SERVICE INSTRUCTIONS

SUBJECT: FORD TRUCKS,9.L VALVE COVER OIL LEAK

INTRODUCTION

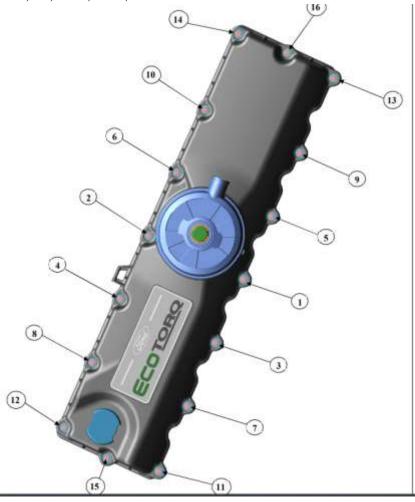
- 1) Remove the cover and inspect the valve cover and its surroundings.
- 2) If oil leakage is detected during the inspections, disassemble the valve cover bolts.
- 3) After the disassembly process, shorten the pilot parts of the bolts.

4)After completing the bolt shortening process, place the valve cover on the cylinder head surface and take up the clearances of the bolts.
